**RE: SUBMISSION TO PARRAMATTA METRO OVER STATION DEVELOPMENT
(SSD-35538829)**

School Infrastructure New South Wales (SINSW), on behalf of the Department of Education (DoE), welcomes the opportunity to provide comments on Concept State Significant Development Application (Concept SSDA) SSD-35538829 for the Parramatta Metro Over Station Development within the block bound by George Street, Church Street, Smith Street and Macquarie Street (the site).

Figure 1: Figure 2-4 of the EIS annotated to show full extent of School boundaries

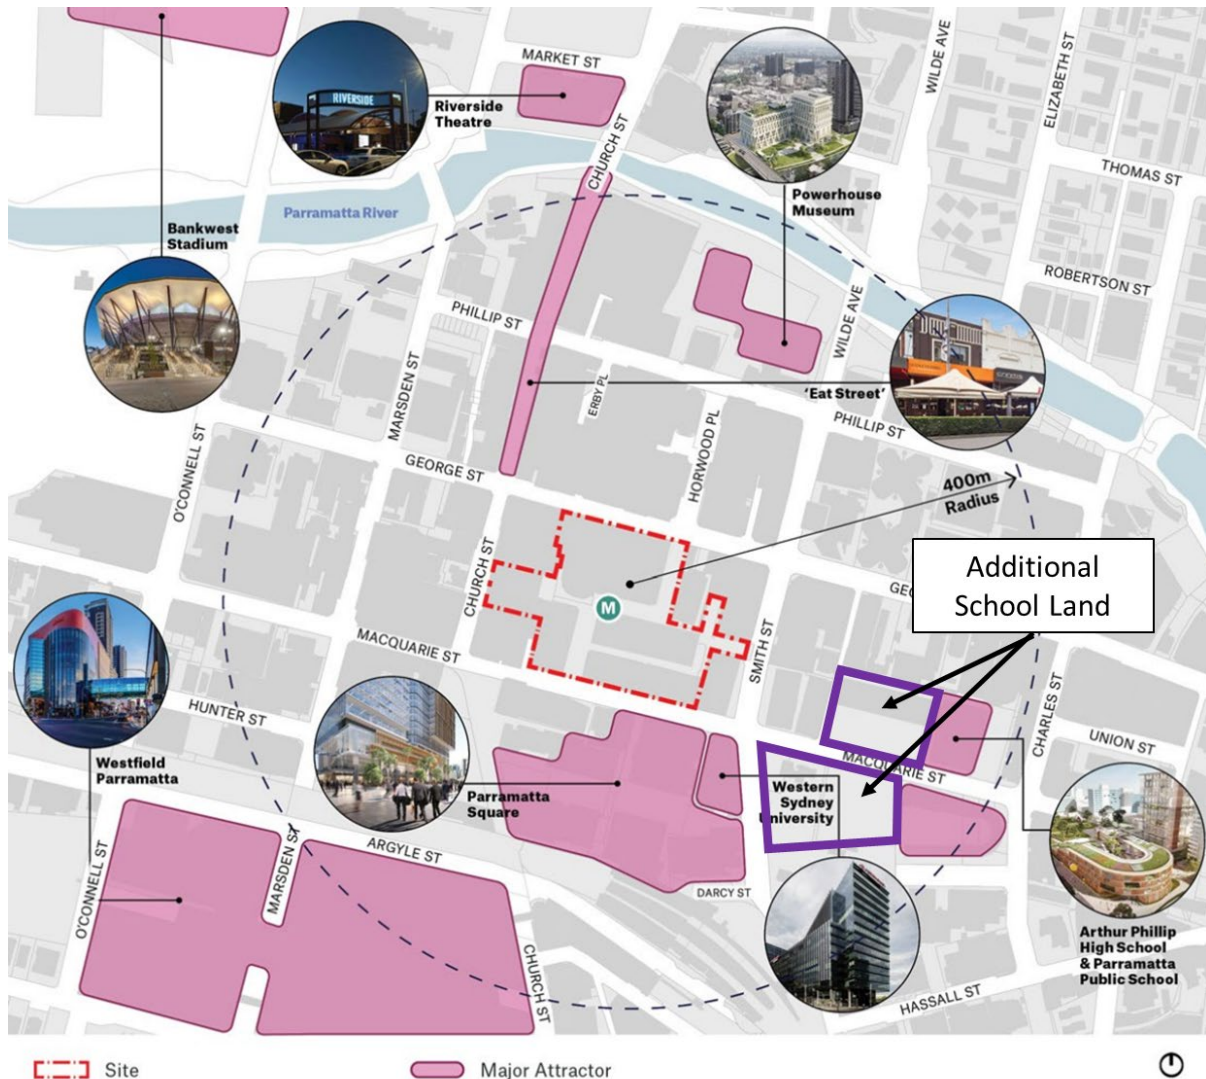
Figure 2-4 within the EIS annotates surrounding development that is considered a major attractor and includes Arthur Phillip High School and Parramatta Public School. However, the boundaries of the school shown on Figure 2-4 do not accurately reflect the current school boundaries as shown below.

It is important the site’s context is accurately considered during the assessment of this application including the schools’ current boundaries. This is particularly relevant for the assessment of overshadowing and amenity as addressed below.
